STRATHFIELD LOCAL PLANNING PANEL MEETING AGENDA

TO: Strathfield Local Planning Panel Meeting - 14 November 2024
 REPORT: SLPP – Report No. 9
 SUBJECT: DA2023.53 - 54 LLANDILO AVENUE STRATHFIELD
 DA NO. 2023.53

Property & DA:	54 Llandilo Avenue STRATHFIELD DA 2023/53
Proposal:	Demolition of structures and alterations and additions to the existing heritage dwelling, excavation for 2 basement parking levels and change of use for the purposes of a childcare centre with capacity for 176 children.
Applicant:	T Geagea
Owner:	Llandilo Property Pty Ltd
Date of lodgement:	28 April 2023
Notification period:	5 May 2023 - 26 May 2023
Submissions received:	Ninety six (96)
Assessment officer:	J Gillies
Estimated cost of works:	\$5,073,294.00
Zoning:	R2-Low Density Residential - SLEP 2012
Heritage:	Yes – Local Heritage Item I172
Flood affected:	No
Is a Clause 4.6 Variation Proposed:	Yes, 16.8% variation to Clause 4.3 height of buildings
Local Planning Panel Criteria	10+ unique submissions & >10% variation to development controls
RECOMMENDATION OF OFFICER:	REFUSAL

Figure 2: Proposed Basement Plan

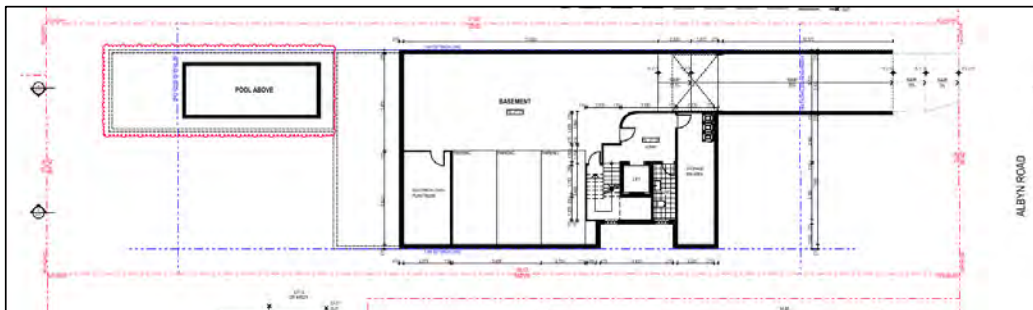
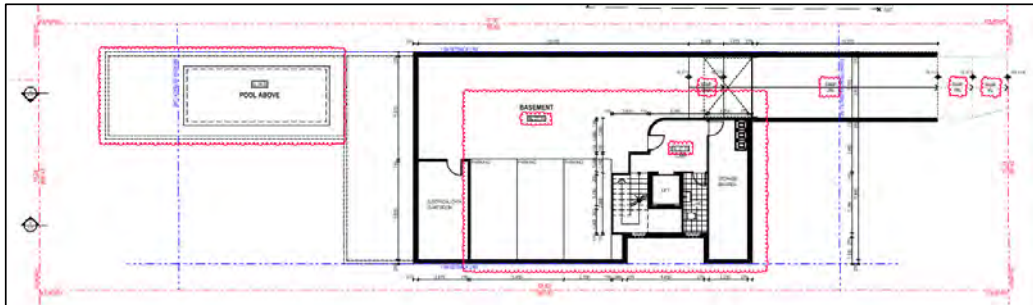
There has been no change in the basement plan with the s8.2 application.

Figure 4: Proposed Ground Floor Plan

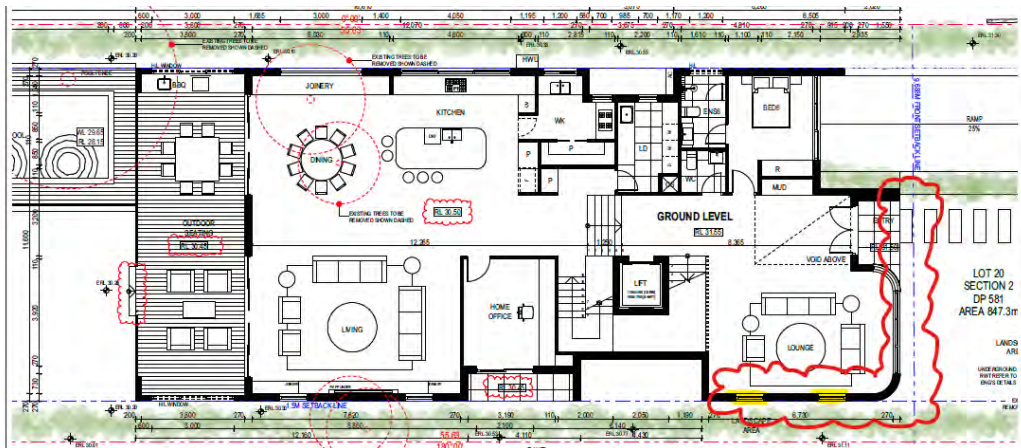
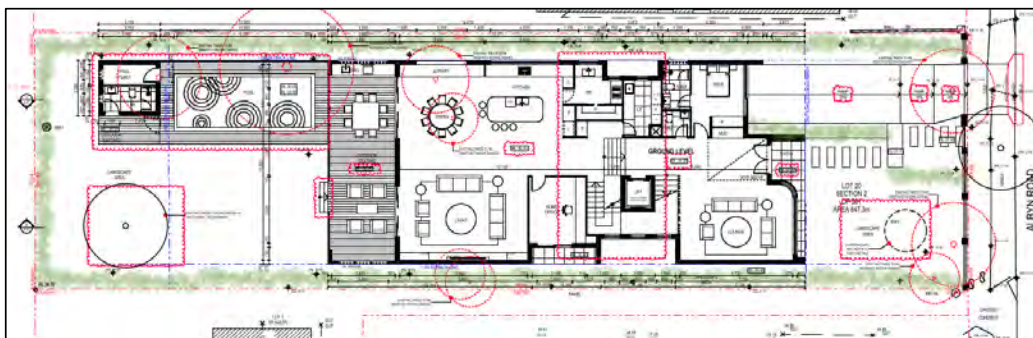
There has been a reduction of 450mm off the front entry, with the tiling and structure in front of the living room removed and the front western corner of the living room has been curved to match the eastern corner. Two windows have also been added to the western elevation of the living room.

Figure 7: Refused First Floor Plan

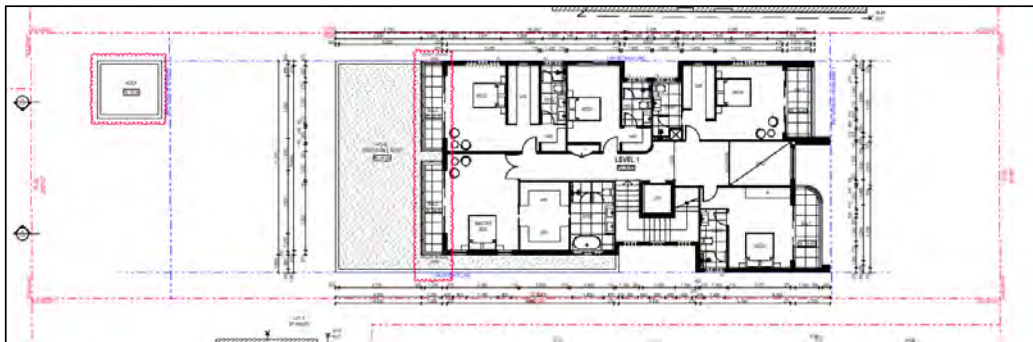
All reduced levels on the first floor have been lowered by 150mm, which has mainly been achieved by reducing the depth for mechanical services between the ground floor ceiling and first floor level, which was very generous in the previous application. The solid wall on the western side of the balcony off the bedroom has been replaced with a curved timber screen and an additional window has been added to the western elevation of bed 5. The three long narrow windows have been replaced with one window over the stairwell.

Figure 10: Proposed Street Elevation

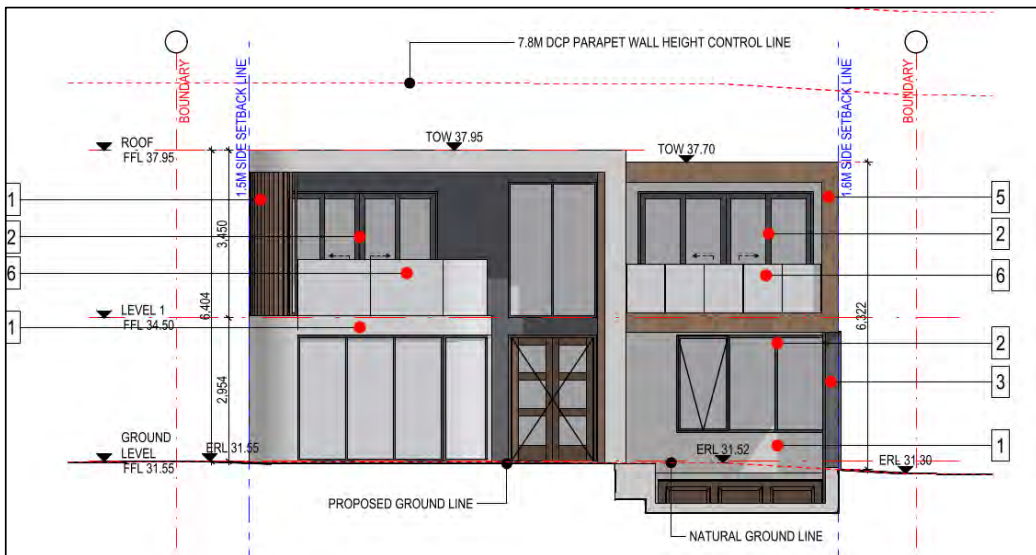
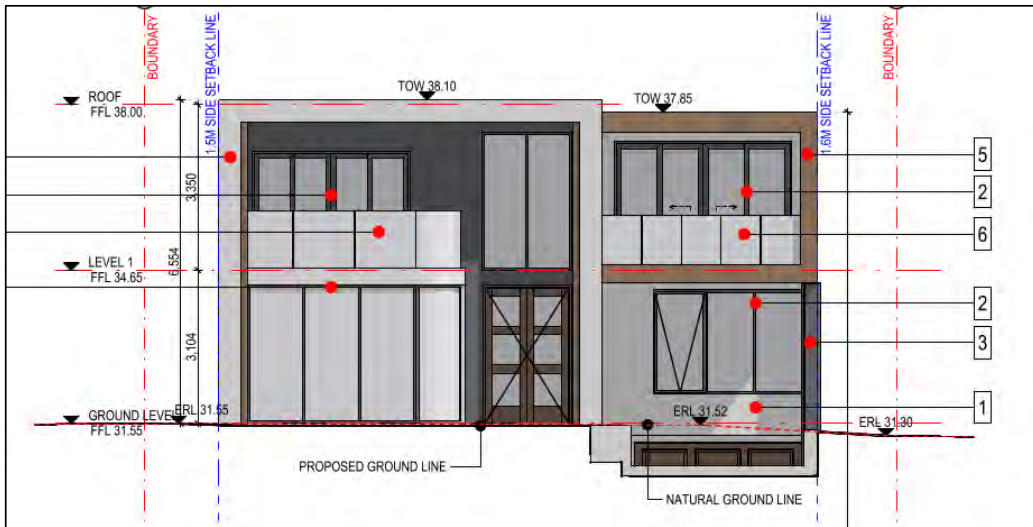
Changes on this elevation sees the introduction of the curved western corner and batten screen on the first floor and the lowering of the building by 150mm.

Figure 12: Proposed Rear Elevation

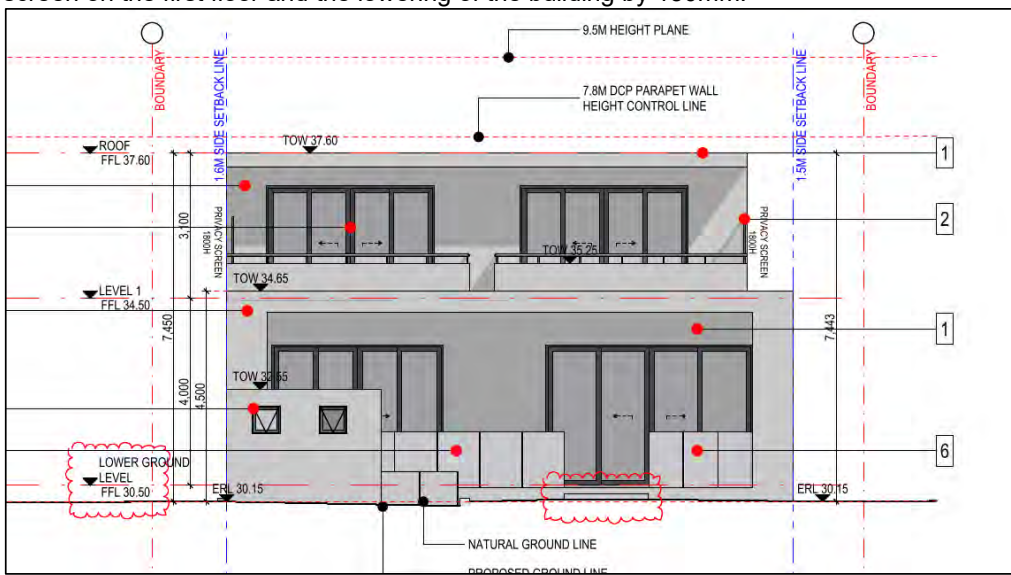
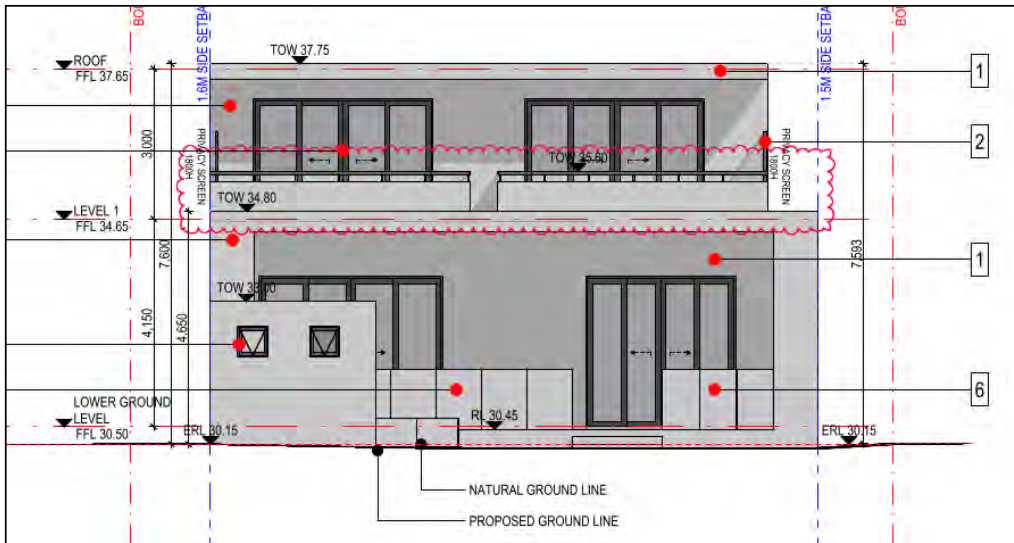
The only visible change on this elevation is the lowering of the building by 150mm. There are no other changes to this façade.

Figure 14: Proposed East Elevation

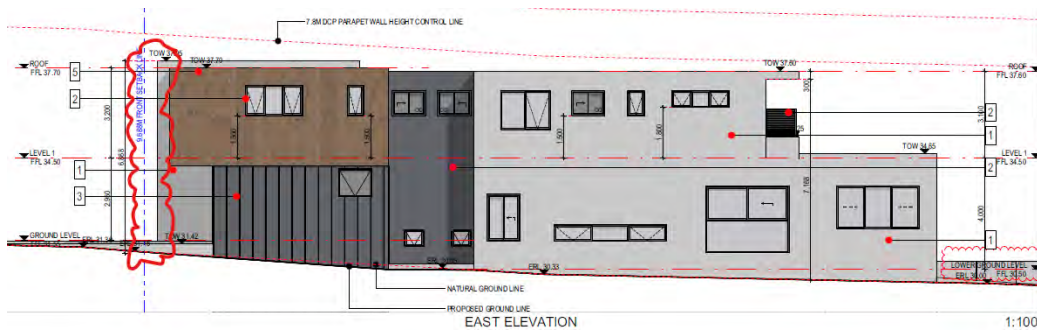
On this elevation, you can see that the front façade has been setback a further 450mm from the 9.688m front setback line and the reduction in overall height.

Figure 16: Proposed West Elevation

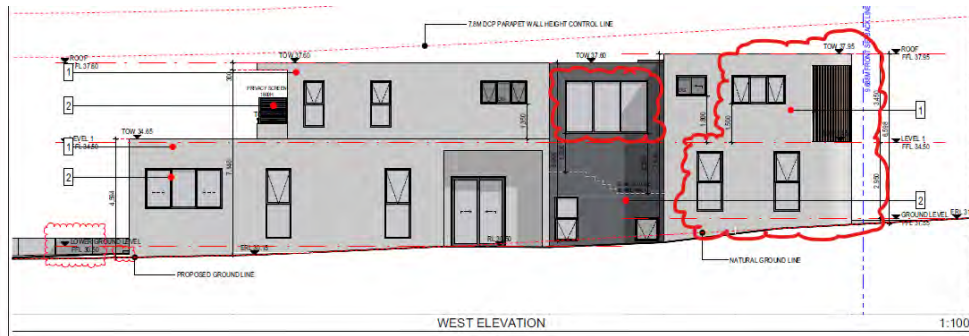
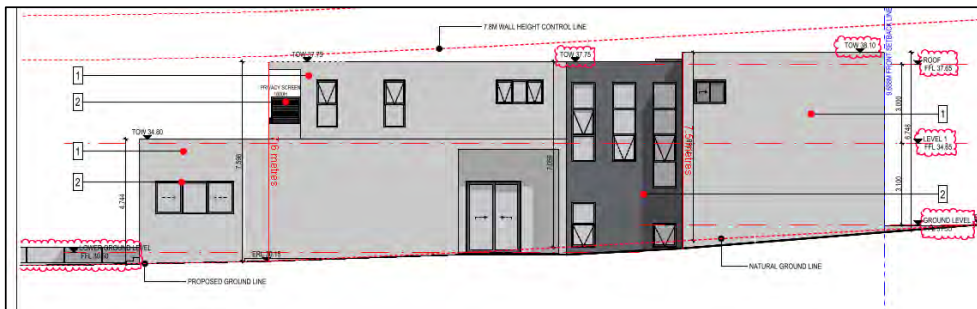
On this elevation, again apart from the lowering in the height, you can see the curved front wall and timber screen across the balcony, the new ground and first floor windows off the living room and bed 5 and the change in window over the stairwell.
